WIPLINE FLOATS | MODIFICATIONS | AIRCRAFT SALES  
 AVIONICS | INTERIORS | MAINTENANCE | PAINT

## SERVICE LETTER 276

### Brake Torque Plate Safety Wire

**Figure 1 – Hardware for Safety Wire (Qtys shown are per Torque Plate)**

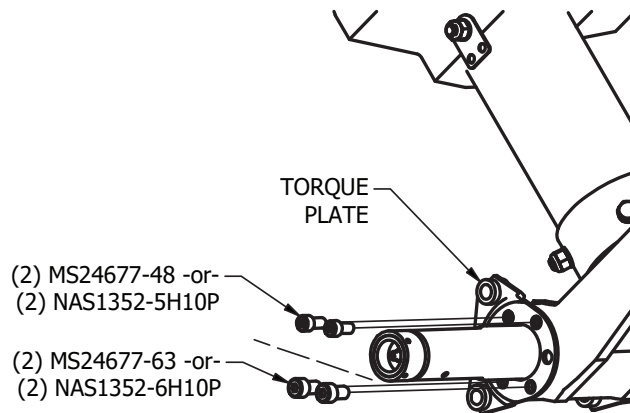
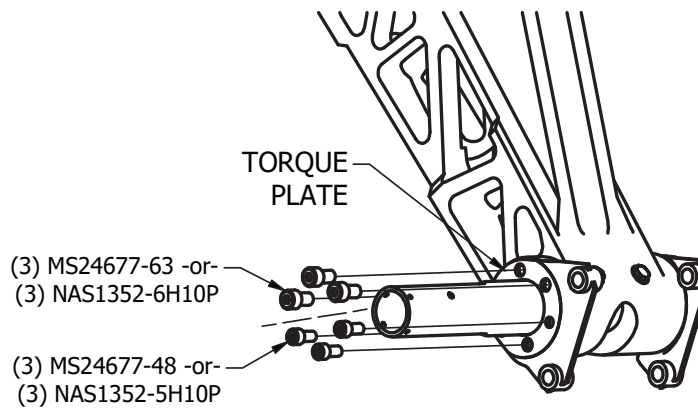
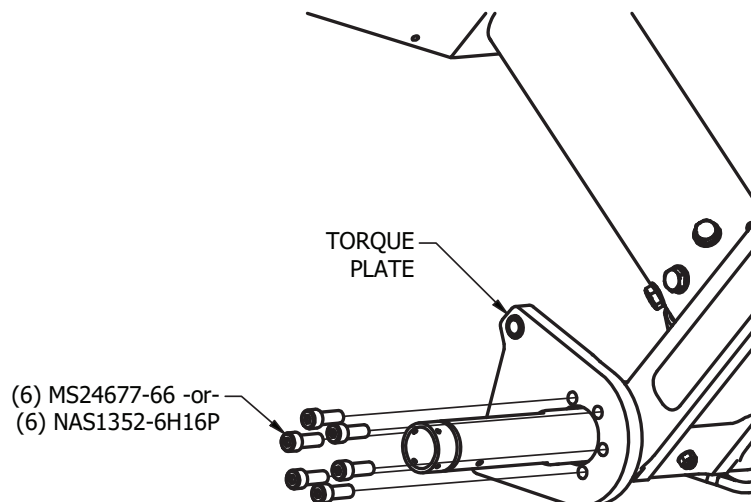
1. Position and prepare aircraft for safe maintenance.
2. Jack or hoist aircraft so that main landing gear wheels can be removed. Refer to associated float Service Manual.
3. Remove brake components and main landing gear wheels to access brake torque plate.
4. Remove and replace torque plate hardware as shown in Figure 1. Threadlocker is recommended (Loctite 242 or equivalent). Torque to:

5/16 screws: 150 in-lbs

3/8 screws: 190 in-lbs

**Figure 2 – Single-Wire Method, Six-Bolt Pattern**

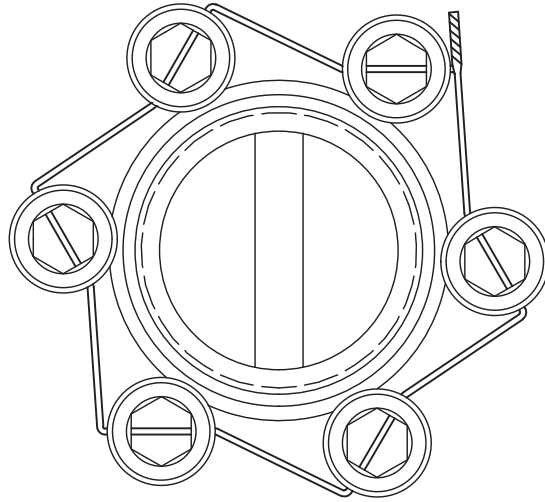
5. Safety wire with MS20995C32 in accordance with AC43.13-1B. Single-wire method is recommended for six-bolt patterns to ensure clearance with axle. Refer to Figure 2.
6. Reinstall brake and wheel components.
